NRA THAMES REGION:

AUDIT SURVEYS 1991/92

A report on the re-surveys of selected reaches of  
river following maintenance dredging.

#### FILCHAMPSTEAD BROOK, FARMOOR RESERVOIR

DREDGING RECOMMENDATIONS ①

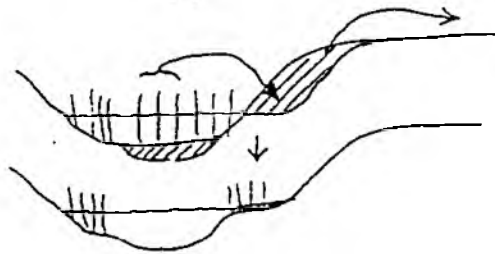
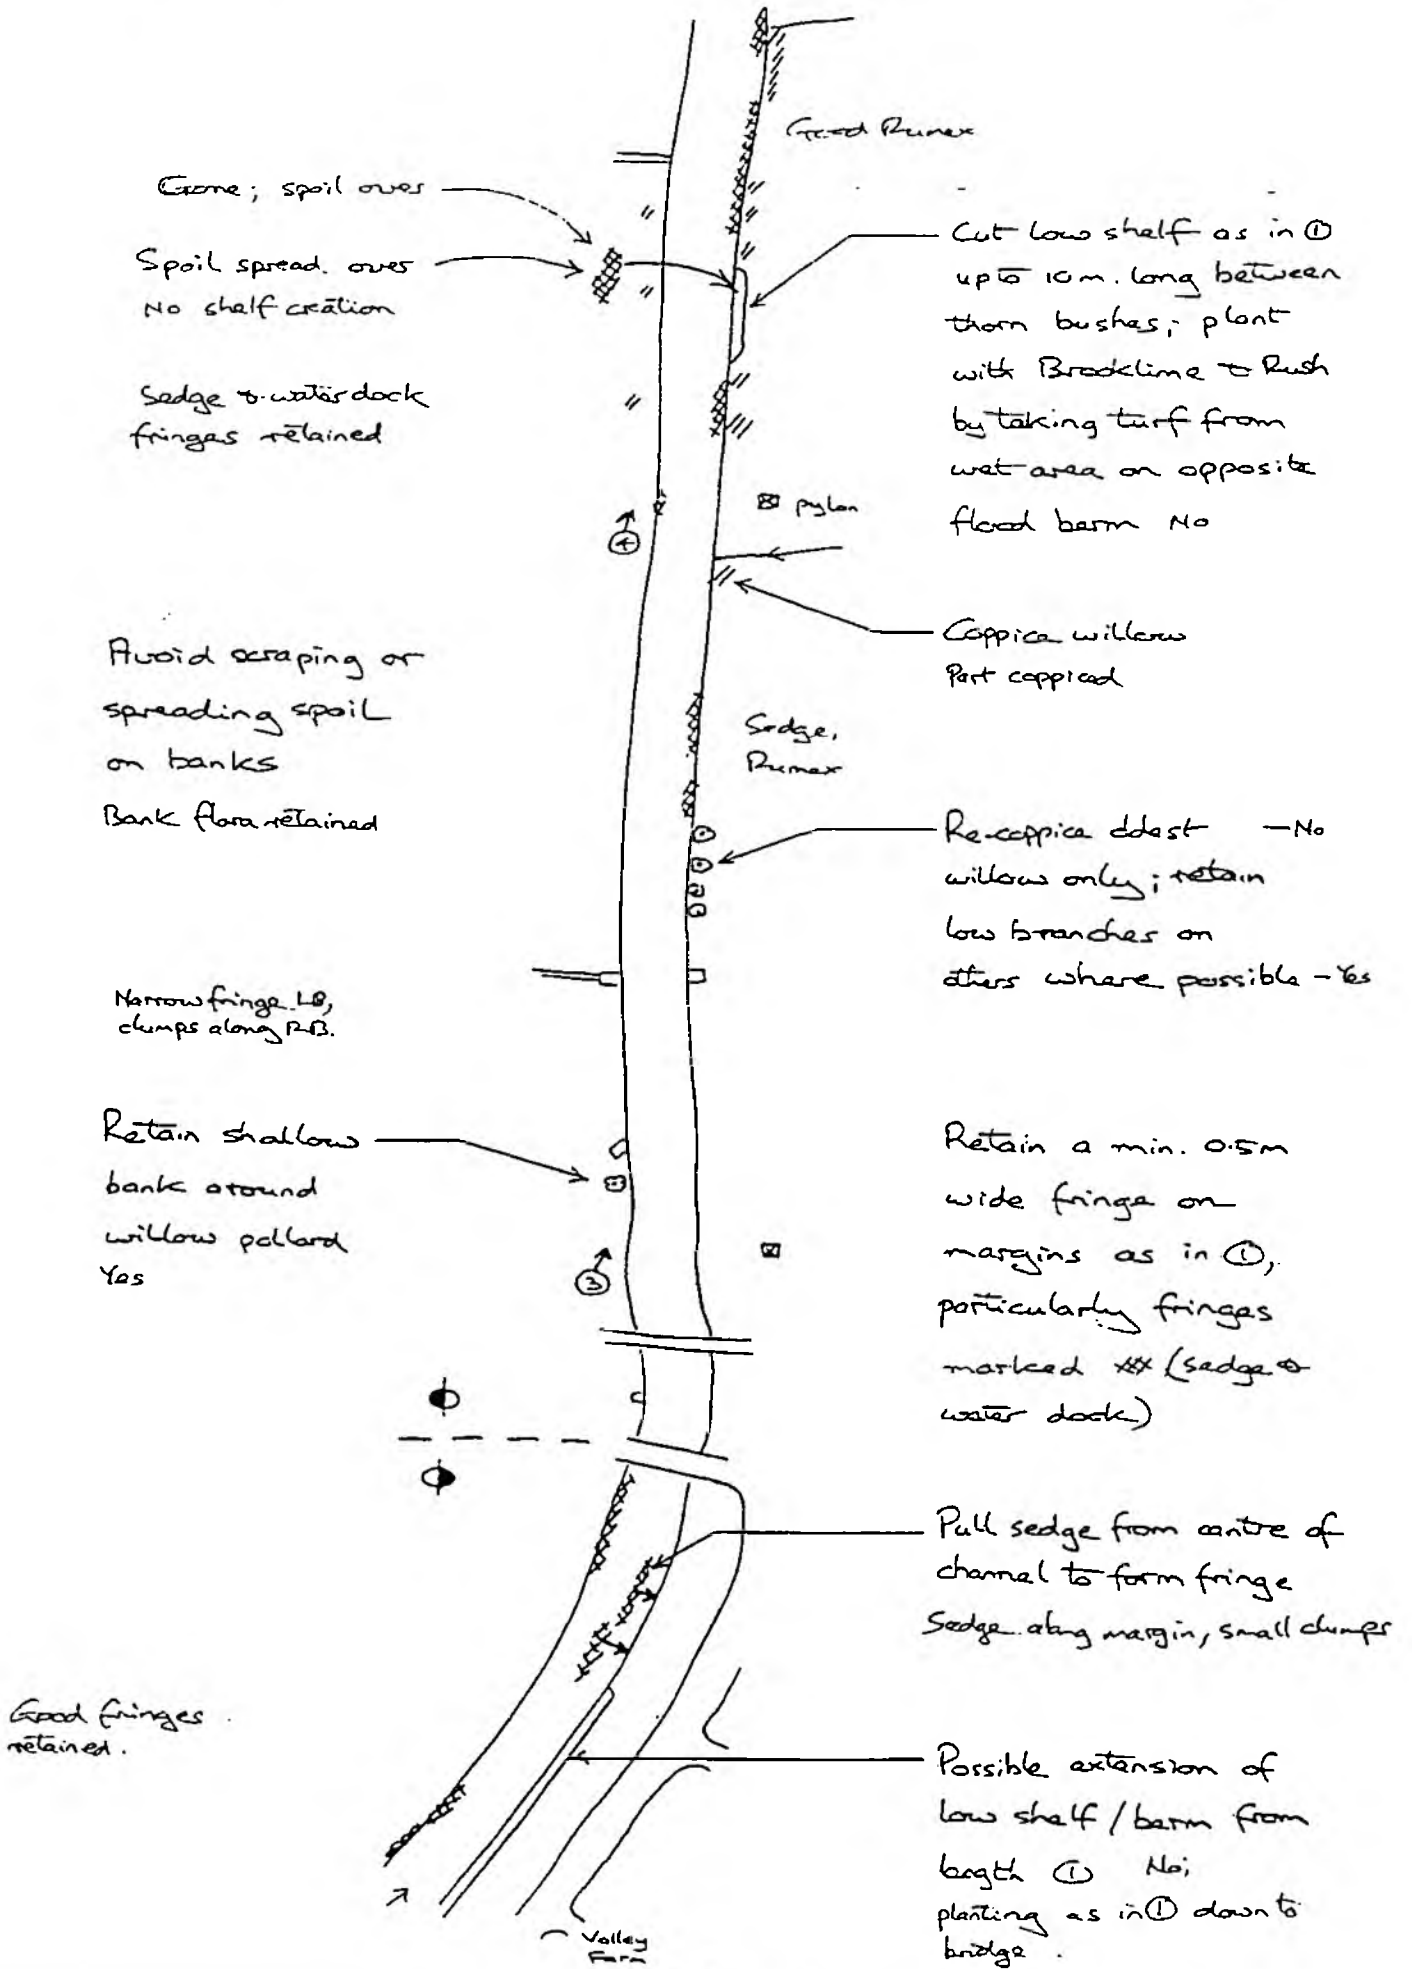
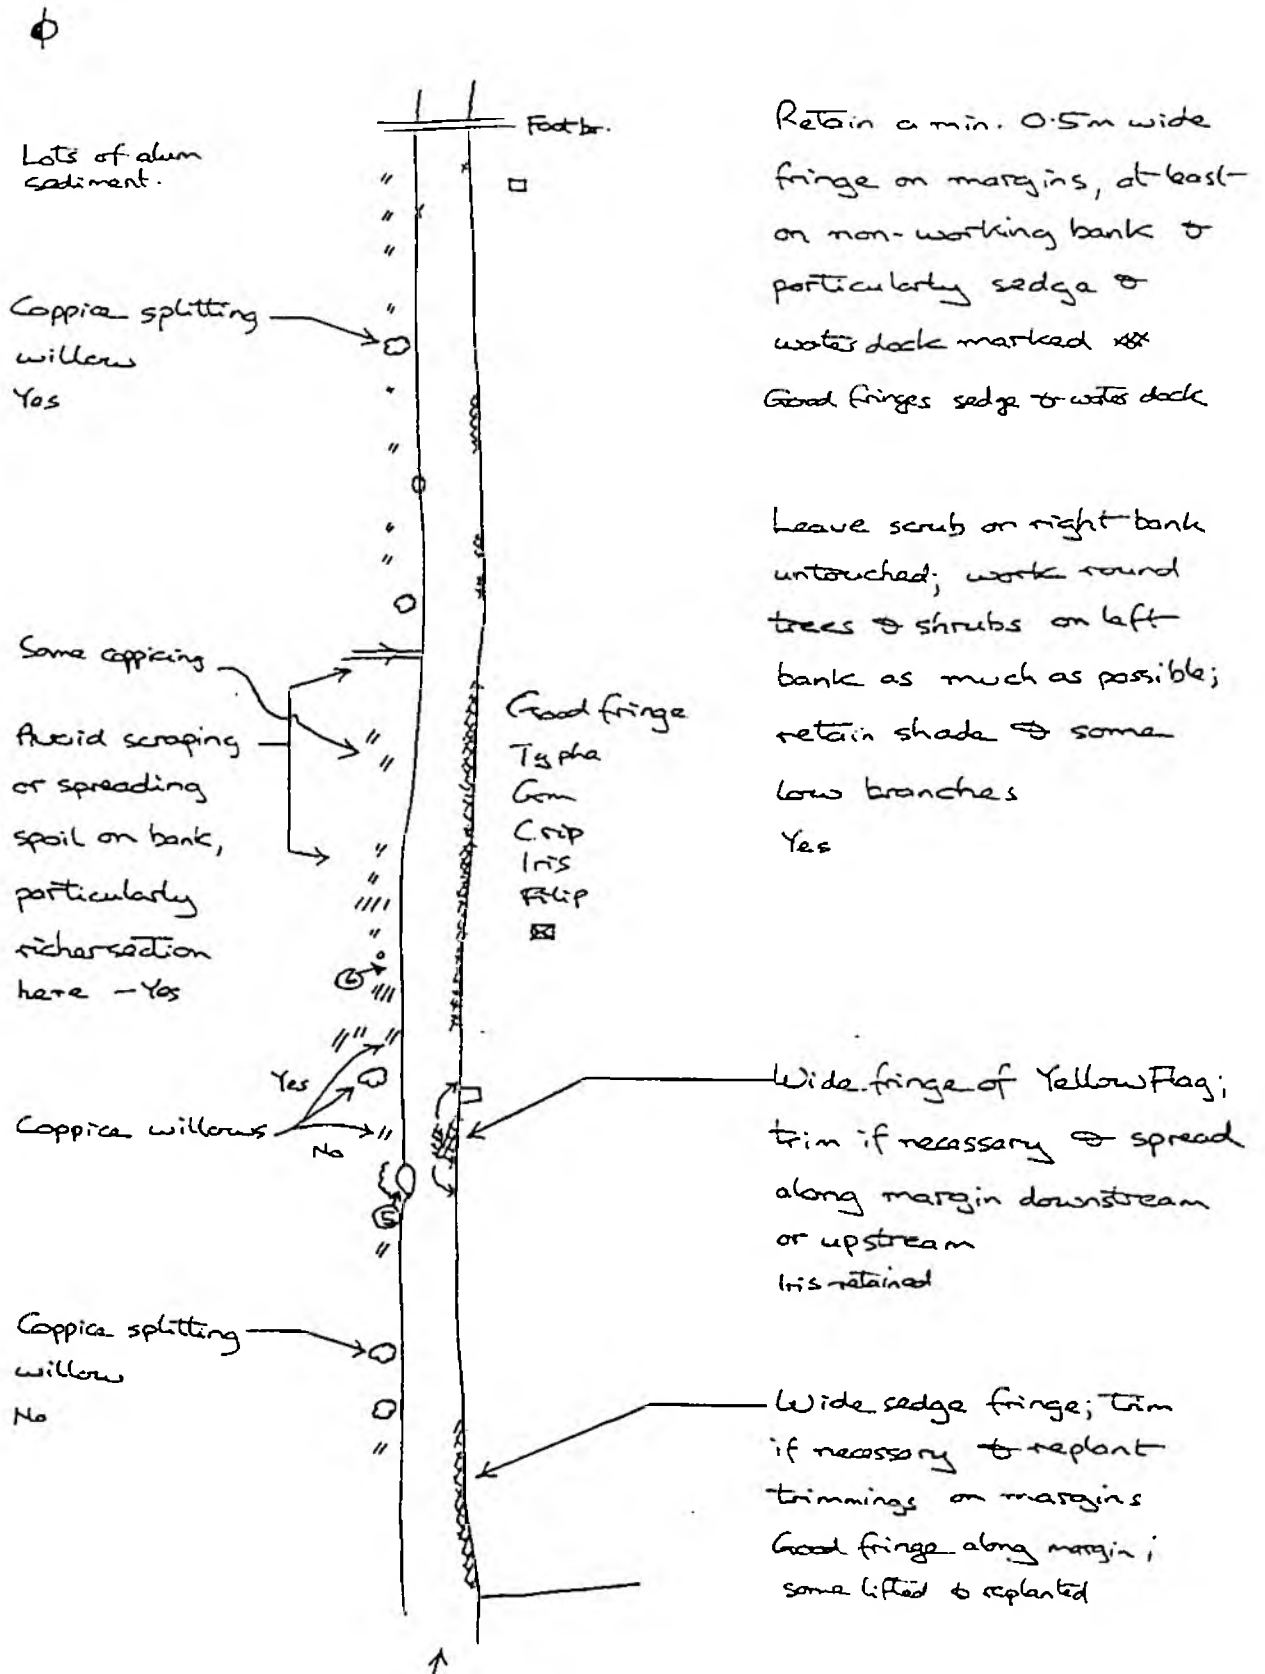
⊙ but see below  
 Coppiced outer branches only  
 Coppice willows; use stakes to enhance bank planting on left → to right  
 Narrow fringe in places

Uprick round trees & shrubs as much as possible & retain shade & some low branches  
 Yes, & in use by Kingfisher

Retain water-cross margins Yes

Leave a min. a 0.5m wide fringe on margins throughout, at least on non-working bank  
 Fringes & bank flares left.

No shelf-tree planting instead  
 Cut a low shelf at normal water-level, 0.5m wide min., 10m+ long if possible, & plant with some of sedge from channel

Toe of both banks scraped

Re-coppice split willow  
 Several willows coppiced

- Spoil spread between hedge & brook  
 Avoid spreading spoil on verge between bank top & hedge, or on bank; either :-
- 1) work from left bank & spread spoil on left;
  - 2) spread spoil between hedge & road, >3m from top of bank;
  - 3) remove spoil to dispose elsewhere
